Sonoran Energy Project

(02-AFC-01C)

Data Responses, Set 1 (Responses to Data Requests 1 to 58)

Submitted to
California Energy Commission

FIGURE DR23-1
Generator Tie Line Land Cover Types and Vegetation Communities
 Sonoran Energy Project
 Riverside County, California

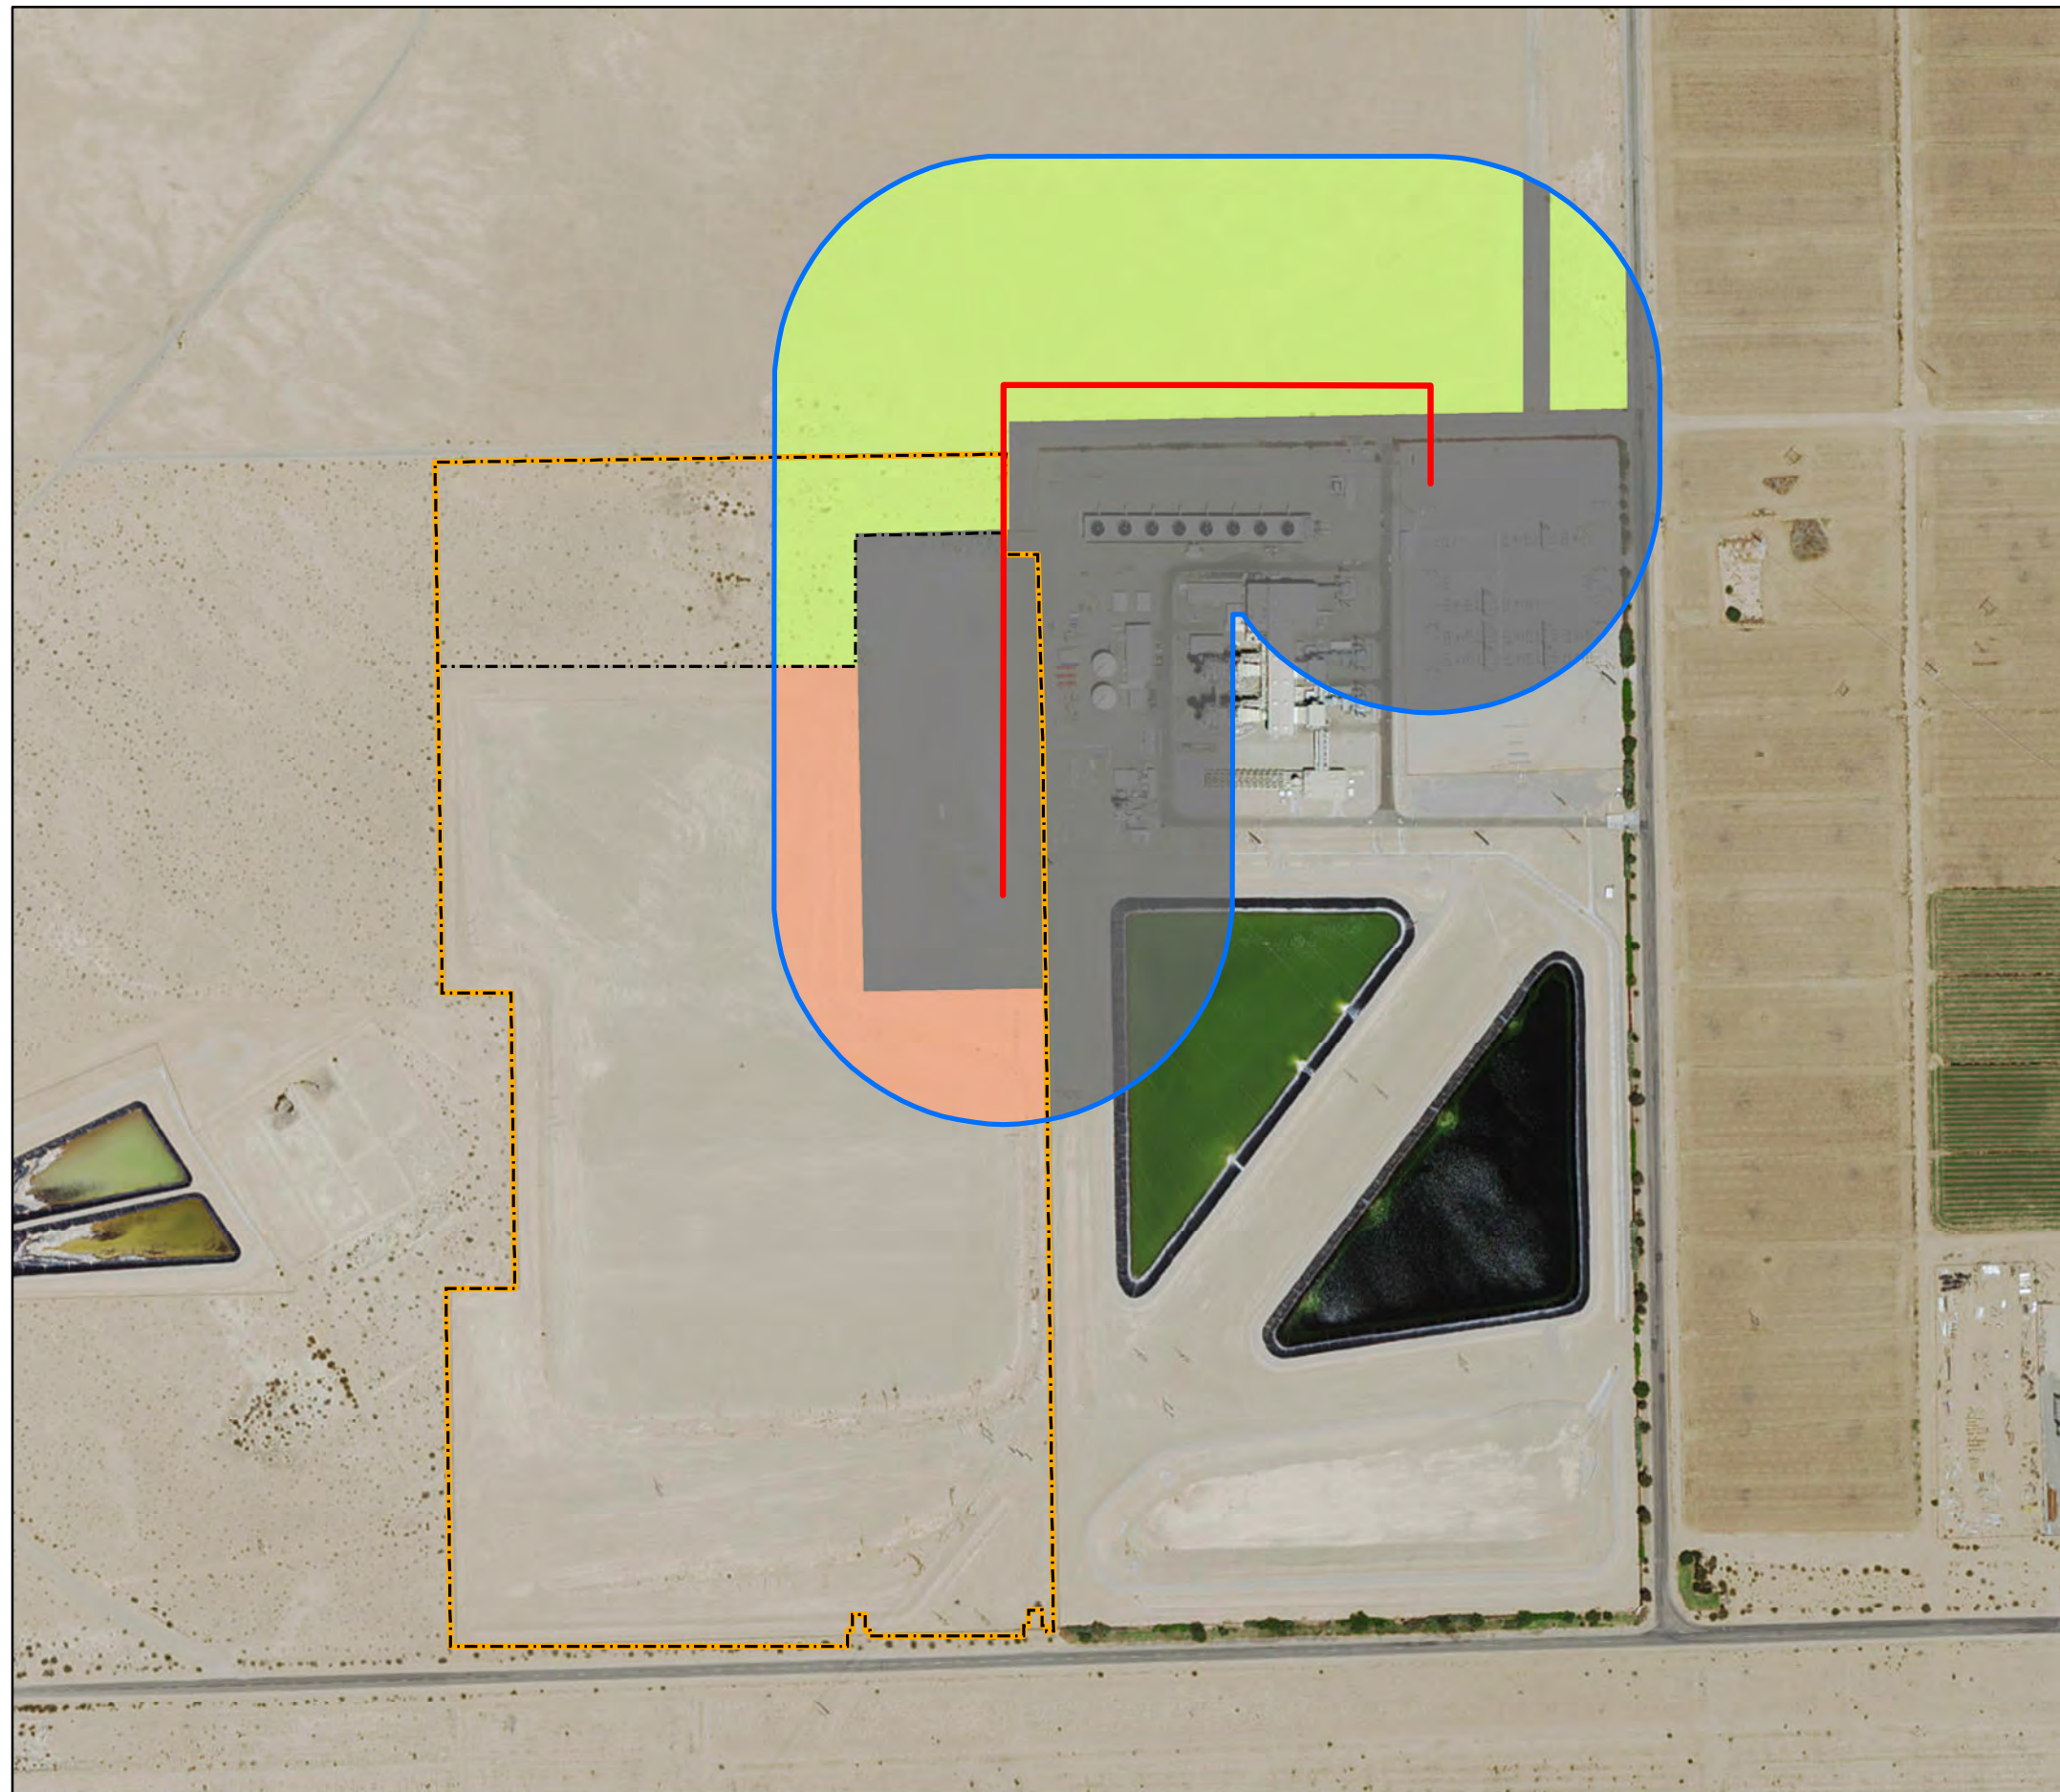
24. Please provide a map that shows the habitats with acres within 500 feet of either side of the Gen-Tie line.

Response: A map showing land cover types and vegetation communities within 500 feet of the generator-tie line is provided as Figure DR23-1.

FIGURE DR26-1
General Arrangement with Ammonia Storage Locations
 Sonoran Energy Project
 Riverside County, California

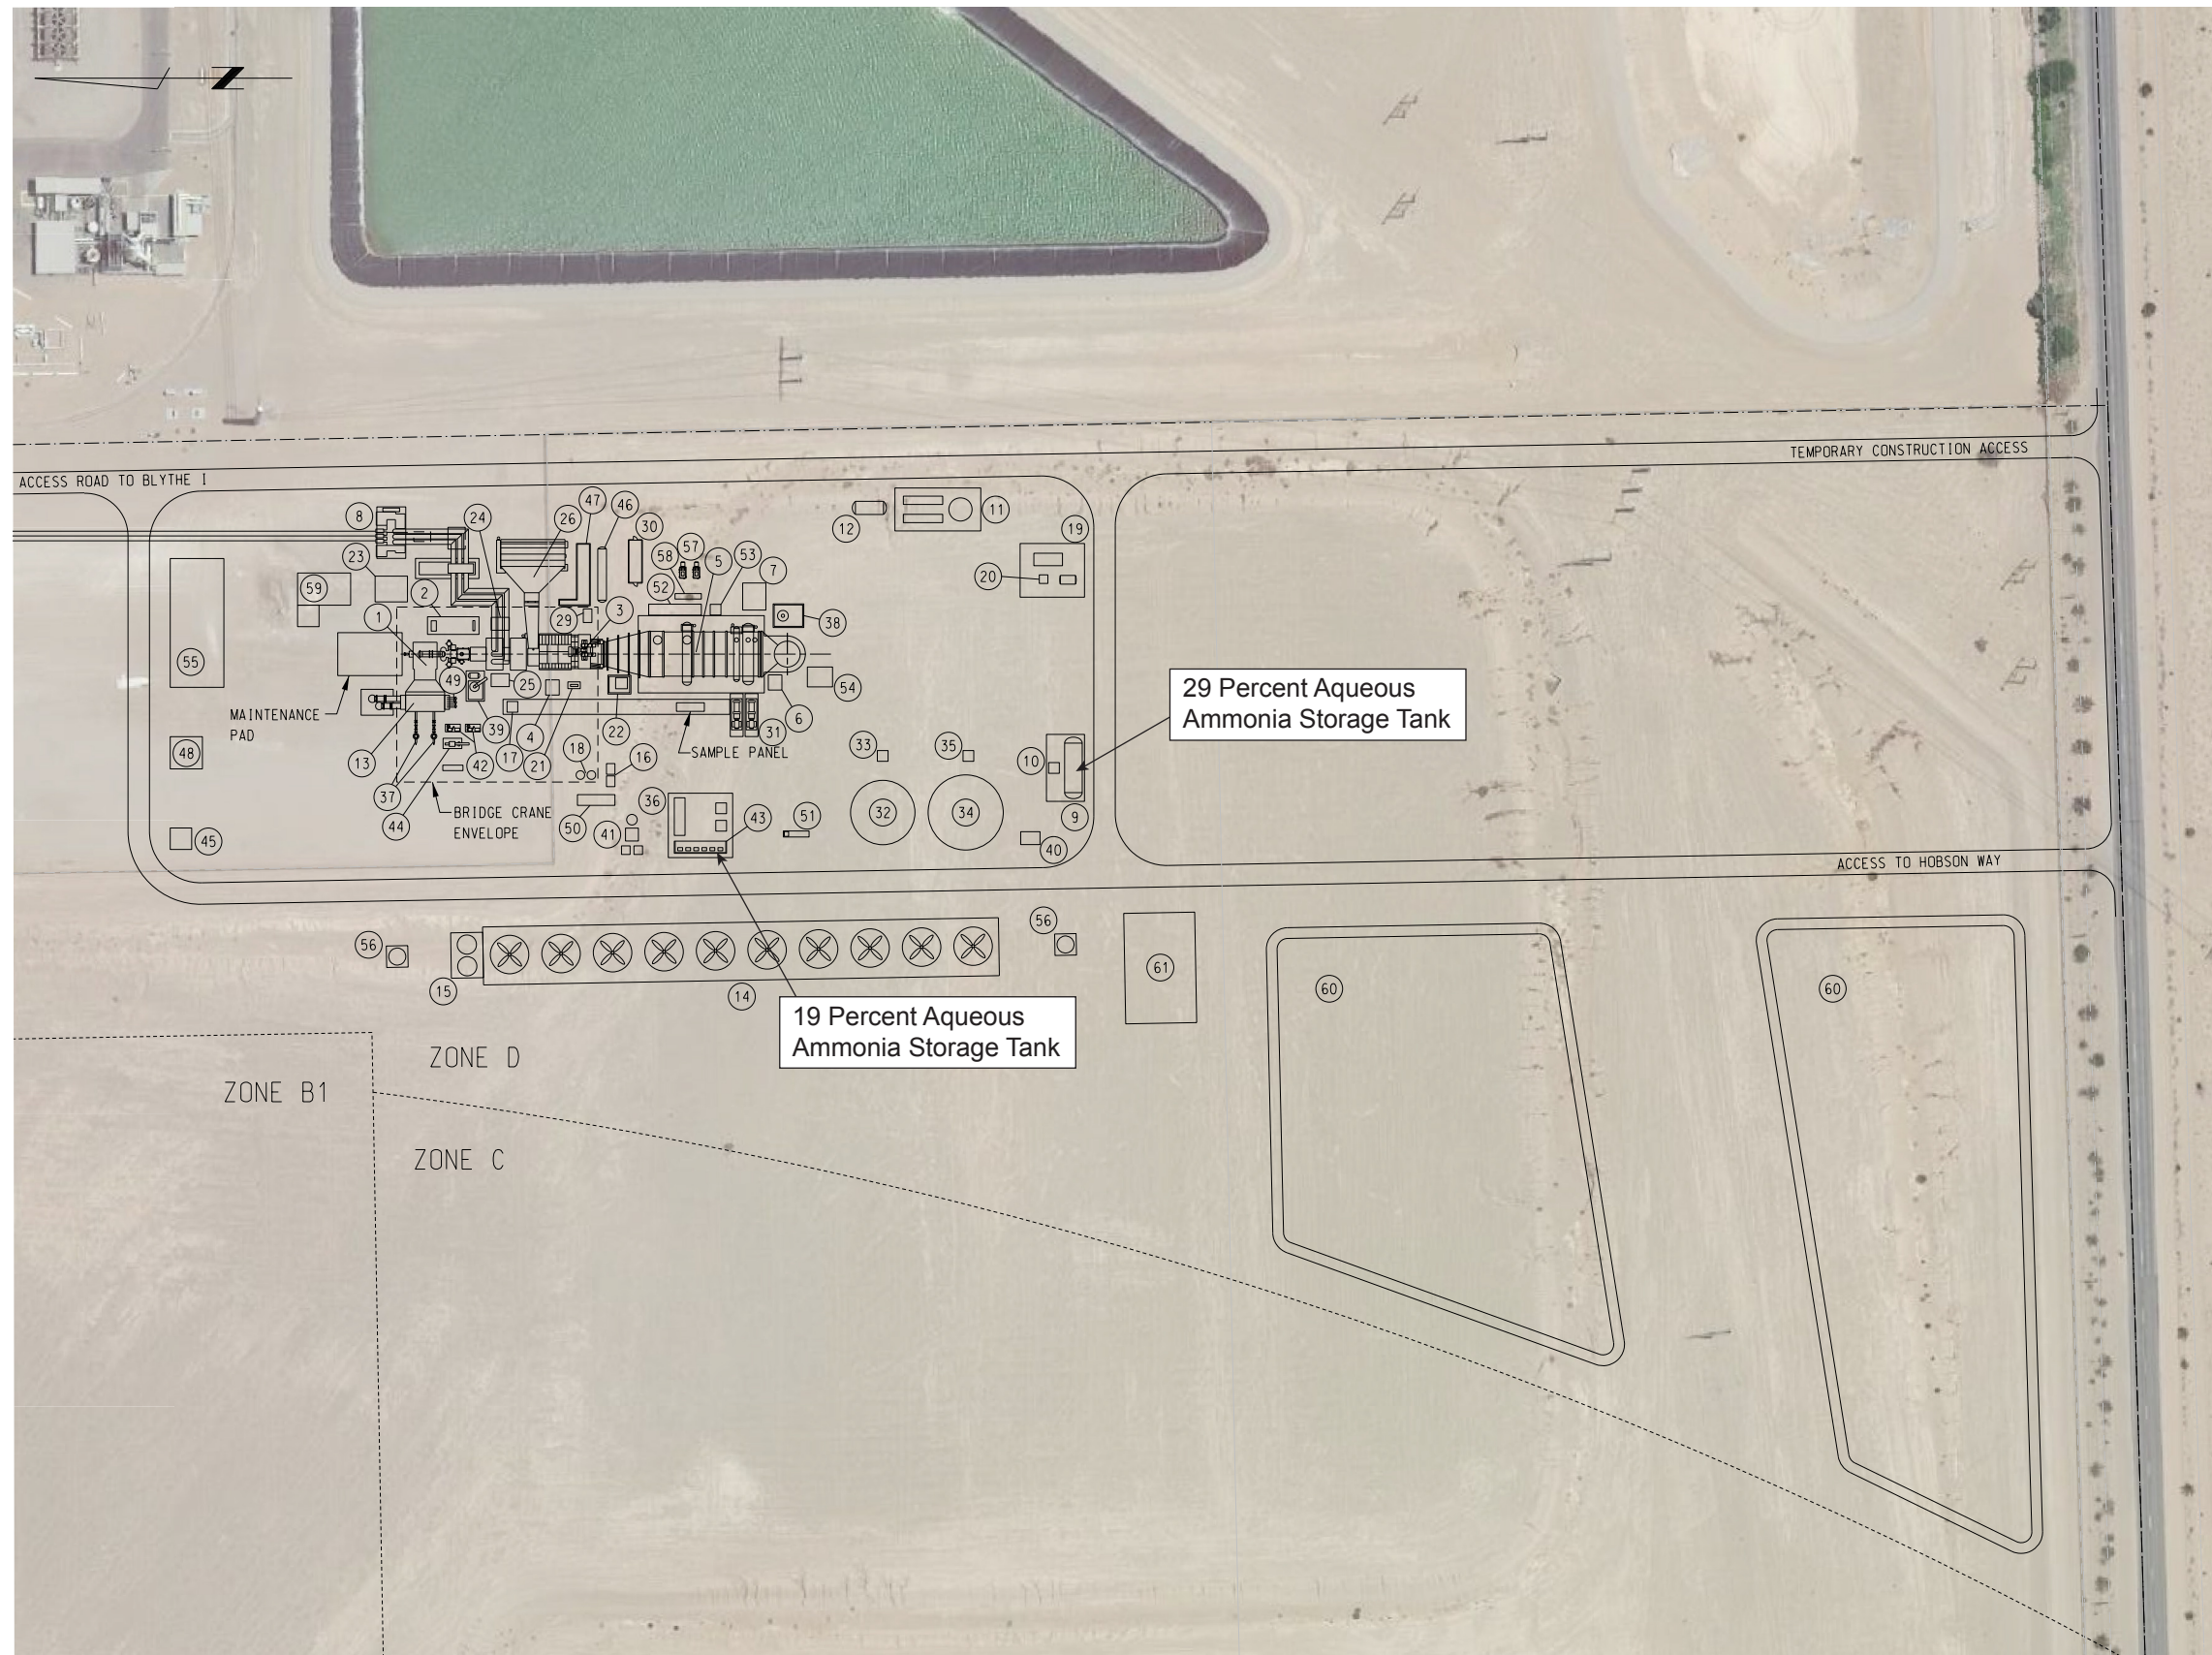
26. Please clarify that SEP will require both types (19 percent and 29 percent by weight) of aqueous ammonia on site and provide a site map with the location showing each of the aqueous ammonia tank locations.

Response: SEP will use both 19 and 29 percent aqueous ammonia onsite. The 19 percent aqueous ammonia is used to adjust the pH of the boiler feedwater and the 29 percent aqueous ammonia is used to control oxides of nitrogen emissions in the turbines selective catalytic reduction system.

Figure DR26-1 presents the locations of the aqueous ammonia use.

FIGURE DR30-1
Blythe II GA and the Airport
Land Use Compatibility Zones
 Sonoran Energy Project
 Riverside County, California

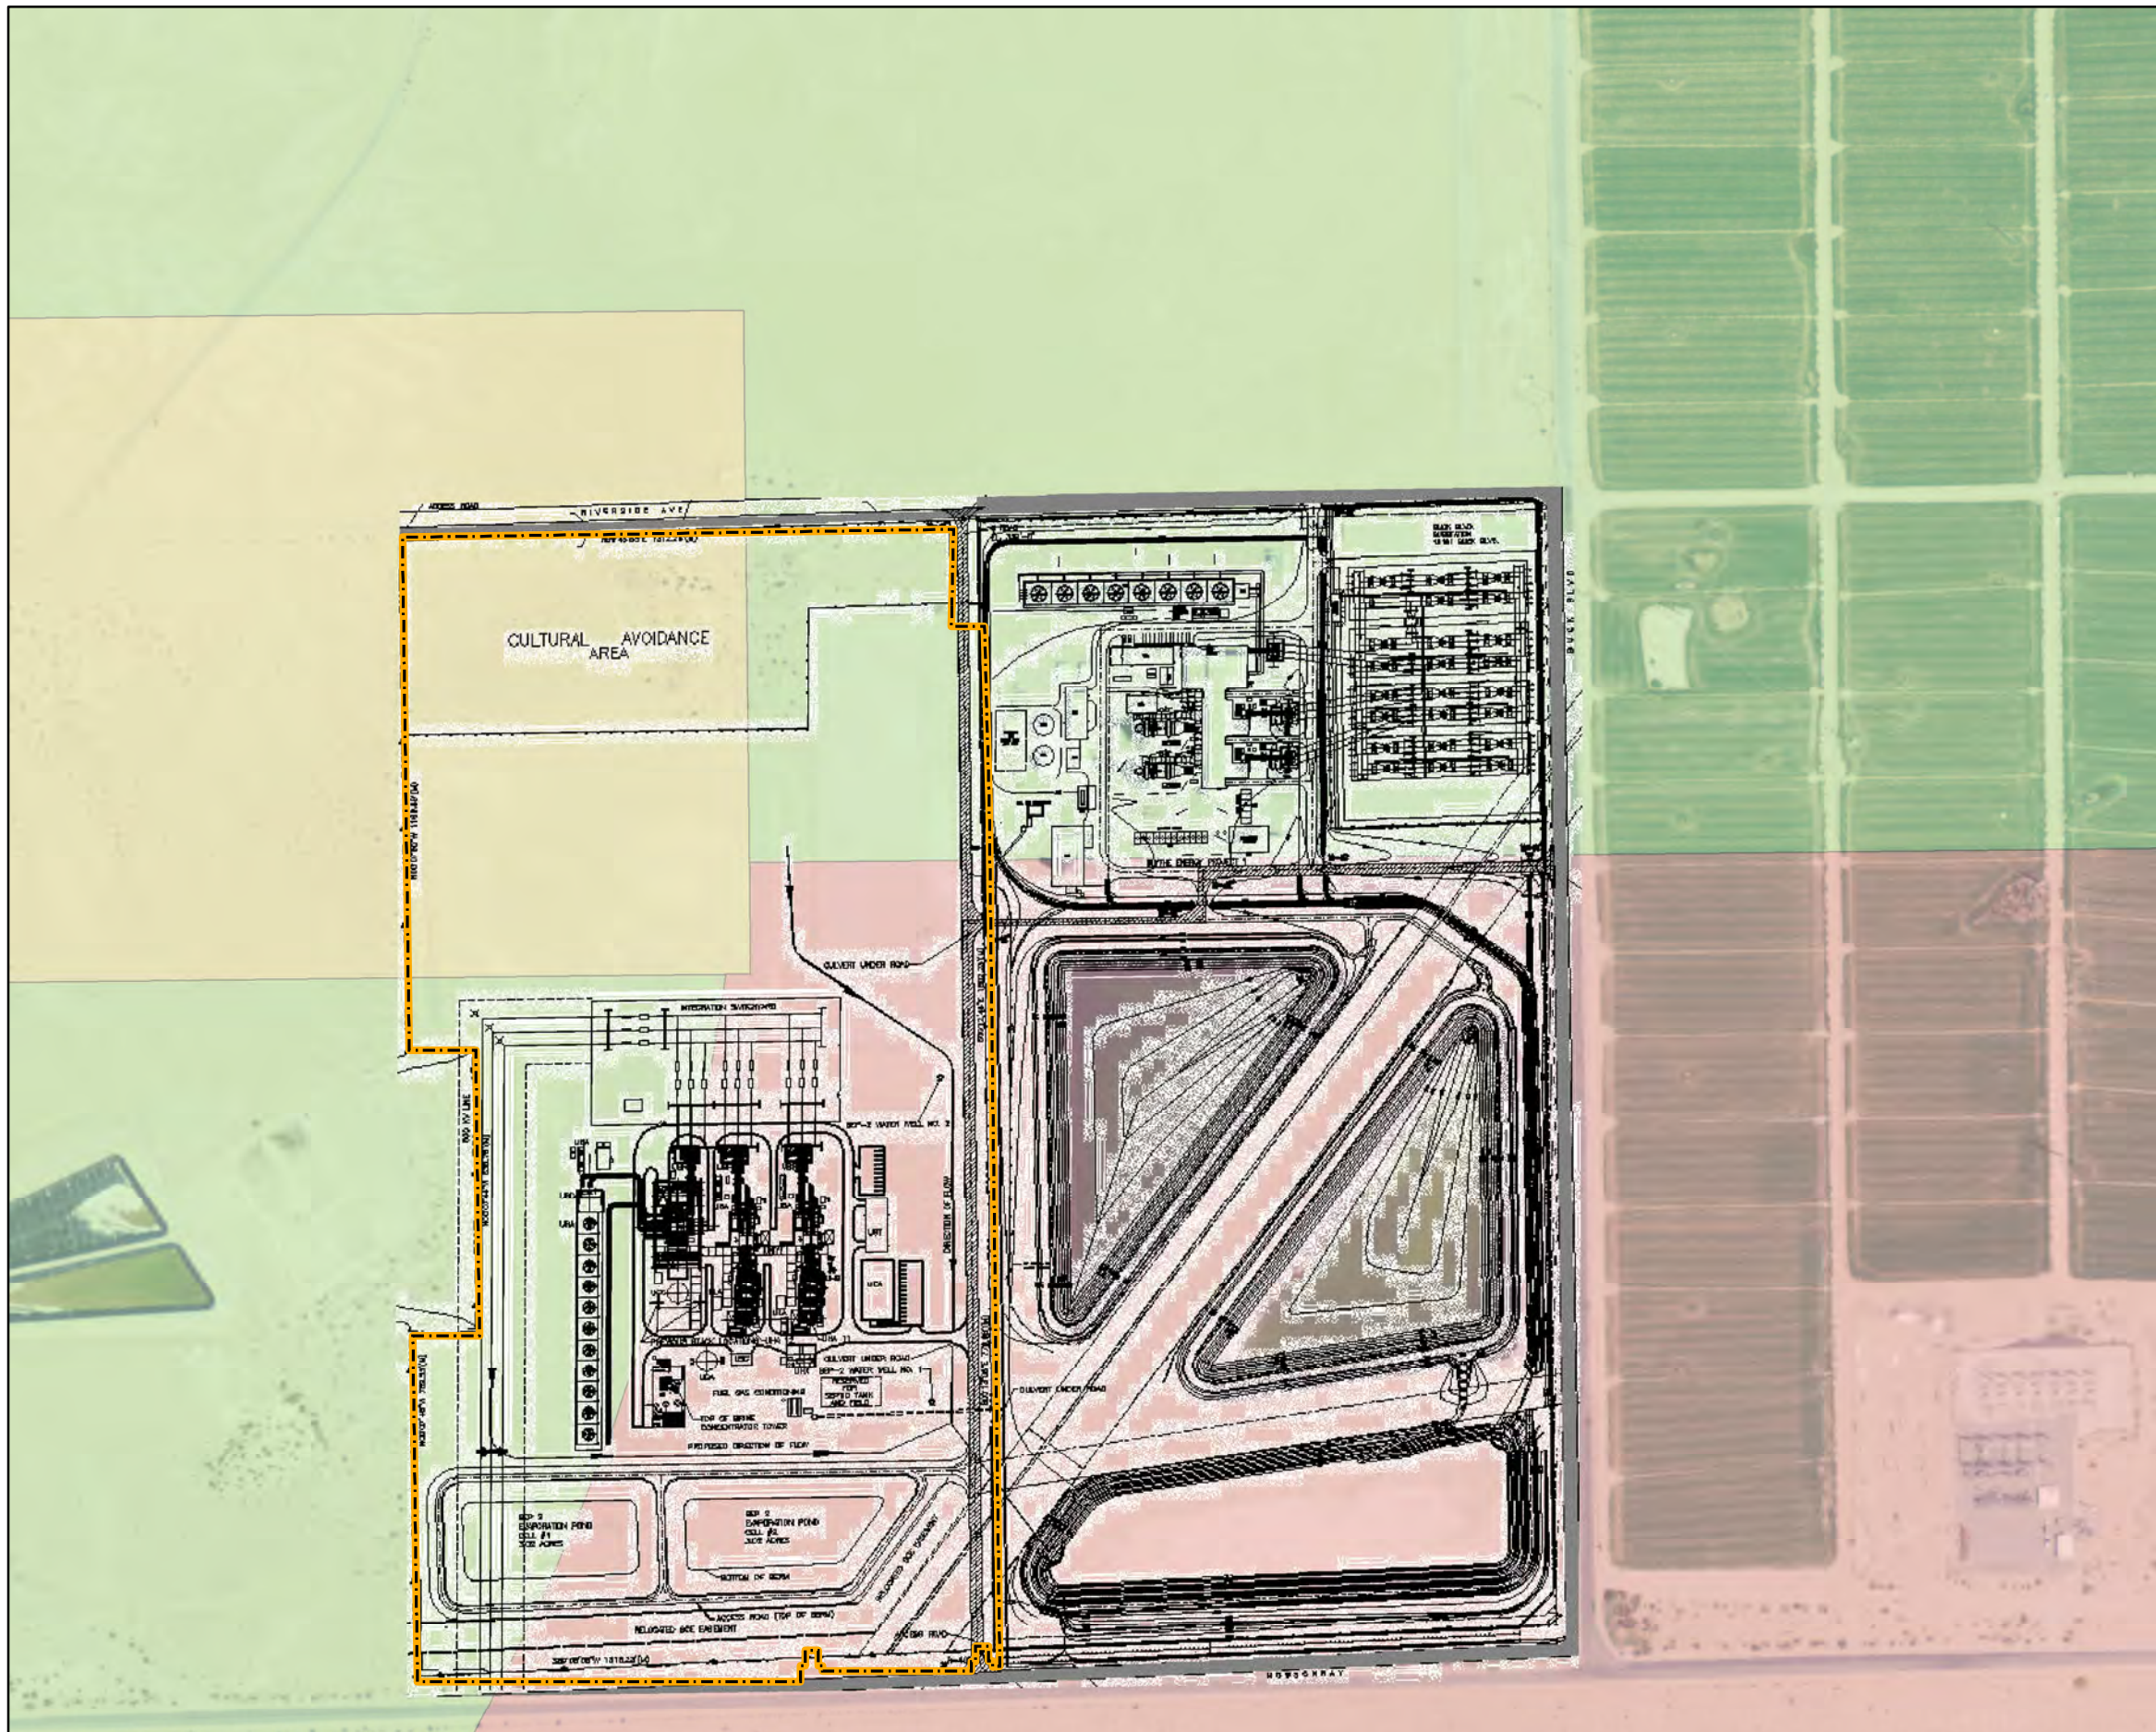
30. Please provide a figure for the licensed project (the Blythe II amendment filed in October 2009) similar to Figure 3.6-2B in the PTA, showing the licensed project’s structures, including the transmission structures, overlaid on the ALUCP Compatibility Zones.

Response: Figure DR30-1 presents an overlay of the Blythe II project (from the October 2009 PTA) and the Airport Land Use Compatibility Zones. Figure DR30-1 includes all project features presented on 2009 Blythe II PTA Figure 1-1.
